Service Information No. **SI 61 004 17**

Service Information No. SI 61 004 17

Battery: Determining the recharging date

Figure: Data matrix code with the last charging date

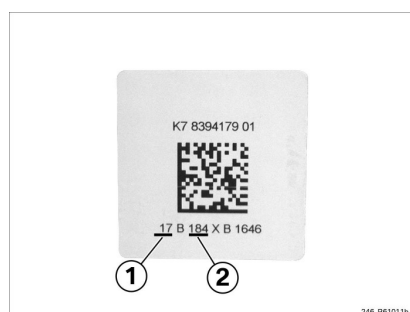
From August 2017, batteries delivered to BMW Motorrad are fitted with a data matrix code by the manufacturer.

The recharging label is (partially) omitted.

The last complete charging date is recorded (calendar day and year) in the data matrix code and also below that in plain text.

The battery must be recharged after 4 months max.

For batteries, which are installed and connected in the vehicle, the time period is reduced to 4 weeks.
